Is your centrifuge having intermittent latch issues like sometimes failing to close the latch? Ozark Biomedical has determined that control boards with old-style shunts (see below) can experience intermittent issues that mimic a defective latch assembly.

Figure 1. Old-Style shunt

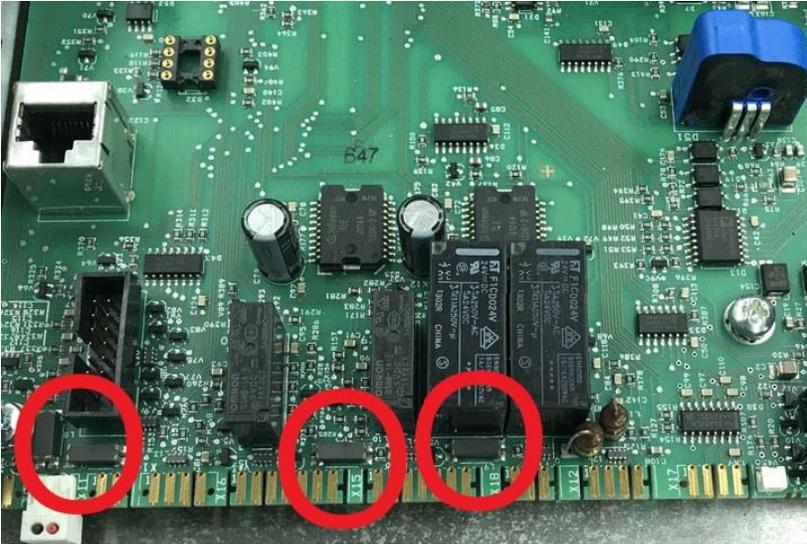
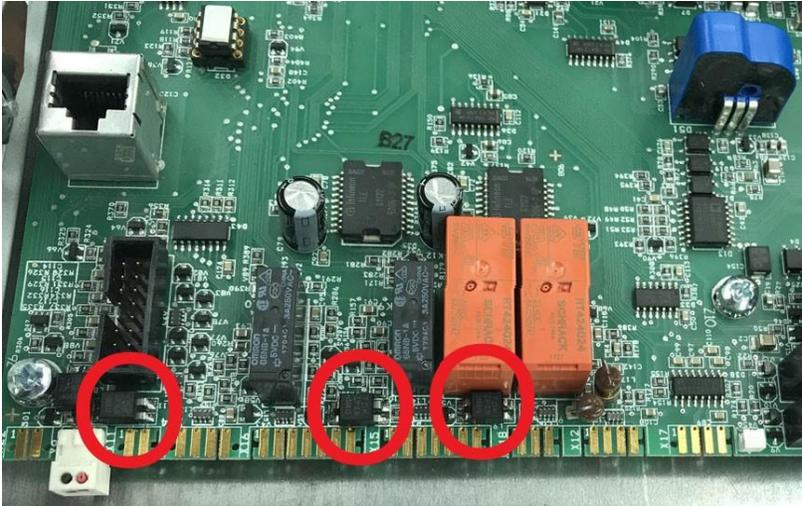
If your board has these old-style shunts, you may need to either replace or have your PCB repaired.
